STAFF EXECUTIVE SUMMARY

Hazelnut Glen Subdivision (PZE-24-0013)

Project Description: The applicants are requesting approval for preliminary plat approval of a multi-phase major subdivision to include 126 Single Family Residential (R1) lots on one lot approximately 38.94 acres in size.

DEVELOPER PROPOSED PHASING PLAN

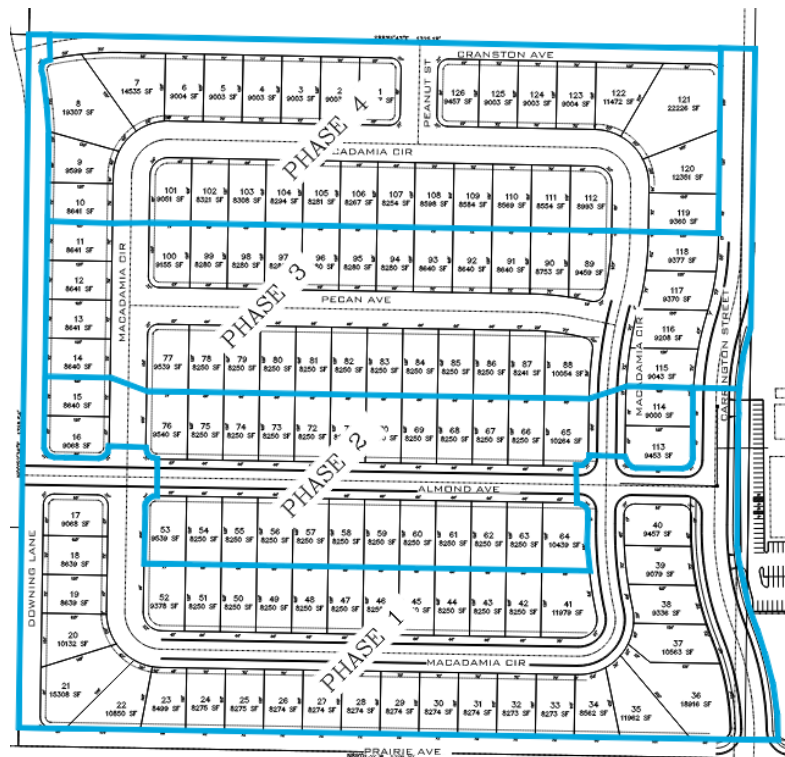
5. The project is a phased subdivision. Certain required infrastructure improvements within the subdivision are requirements of the subdivision as a whole, and some are requirements of each sub-phase of the subdivision. A phasing plan and Table 1-Phasing Summary (pages 14-17 of the Staff Analysis & shown below) shall be made a part of these conditions and is referenced throughout the conditions of approval
